Access Compliance Report

Public Rights-of-Way

Intersection ID: 42734	Main Street: GRIER_SPRINGS_LN	Cross Street: CALDWELL_FOREST_DR	Location: E
ADA ID: 226B7D245B87	Ramp Type: PerpDiag	Initial Pass/Fail: Fail	Overall Compliance: No
Severity Score: 17.5			
Codes/Mitigation Info/Possible Solution		Field Measurements/Component Compliance

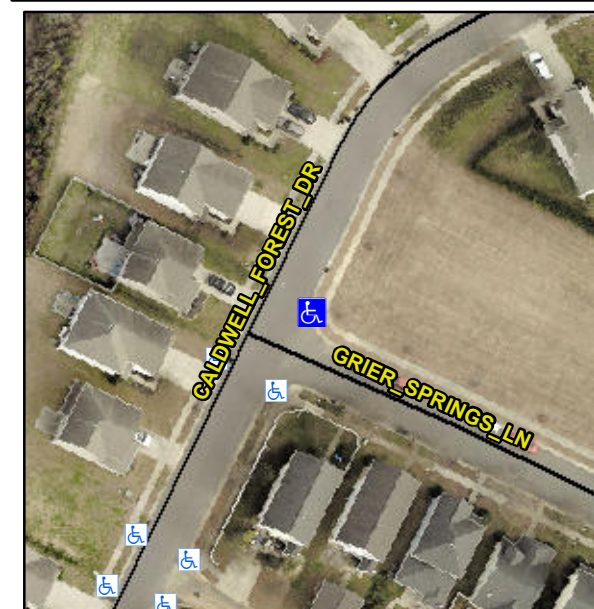
Not Found, R304.5.1

Compliance	Description	Data	Compliance	Description	Data
N/A	Ramp Length (in)	51.0	Yes	Ramp Slope (%)	6.1
No	Ramp Width (in)	32.0	Yes	Ramp XSlope (%)	0.3
N/A	Flare Type LT	N/A	N/A	Flare Type RT	N/A
N/A	Flare Slope LT (%)	N/A	N/A	Flare Slope RT (%)	N/A
N/A	Flare Traversable LT?	N/A	N/A	Flare Traversable RT?	N/A
N/A	Landing Length (in)	N/A	N/A	DWS Provided?	N/A
N/A	Landing Width (in)	N/A	N/A	DWS Contrast?	N/A
N/A	Landing Slope (%)	N/A	N/A	DWS Length (in)	N/A
N/A	Landing X Slope (%)	N/A	N/A	DWS Full Width?	N/A
N/A	Landing Curb? (Y/N)	N/A	N/A	DWS Offset (in)	N/A
N/A	Shared Landing?	N/A			
N/A	Gutter Ponding?	N/A	N/A	Gutter Slope (%)	N/A
N/A	Gutter Lip Ht (in)	N/A	N/A	Gutter X Slope (%)	N/A
N/A	Painted X Walk1?	No	N/A	Painted X Walk2?	No
	X Walk 1 Direction	To W		X Walk 2 Direction	To S
N/A	X Walk 1 Width (in)	N/A	N/A	X Walk 2 Width (in)	N/A
	X Walk 1 Slope (%)	3.3		X Walk 2 Slope (%)	3.5
	X Walk 1 X Slope (%)	4.6		X Walk 2 X Slope (%)	2.7

Remove & Replace Curb Ramp With Two New Directional Ramps or Equivalent.
